RENESAS TECHNICAL UPDATE

Product Category	MPU/MCU	Document No.	TN-RZ*-A0101A/E	Rev.	1.00			
Title	RZ/G1H, G1M, G1N and G1E Document Cor VSP1	Information Category	Technical Notification					
Applicable Product	RZ/G Series,	Lot No.						
	RZ/G1H, RZ/G1M, RZ/G1N, RZ/G1E	All lots	Reference Document	RZ/G Series, User's Manual: Hardware Rev.1.00 (R01UH0543EJ0100)				
This technica	I update describes document correction of RZ	/G Series pr	oduct.					
[Summary]								
Document co	prrection for RZ/G Series, User's Manual: Hard	ware Rev.1.	00.					
[Priority level]							
Importance: "	'Normal"							
Urgency: "No								
[Products]								
RZ/G1H								
RZ/G1M								
RZ/G1N								
RZ/G1E								
[Section num	ber and title]							
Section 28. VSP1

1. Section 28. VSP1, Page 28-54, Section 28.2.5.9 WPFn Output Line Count Register (VI6_WPFn_LINE_CNT: n = 0, 1, 2, 3).

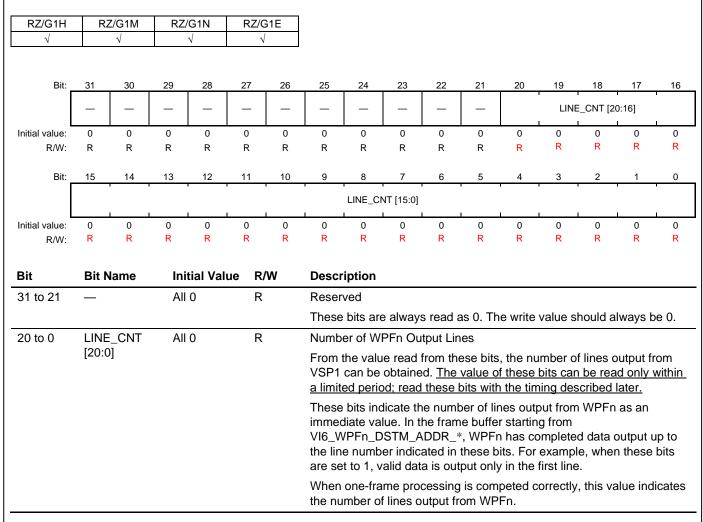
Clerical error in Register bit assign table.

Correction of errors for Register bit assign table.

The LINE_CNT value is valid only for the period between a frame end interrupt (section 28.2.5.6) and next frame startup (section 28.2.5.1) or the period between a display list frame end interrupt (section 28.2.5.6) and next frame startup. This register value read outside these periods cannot be used.
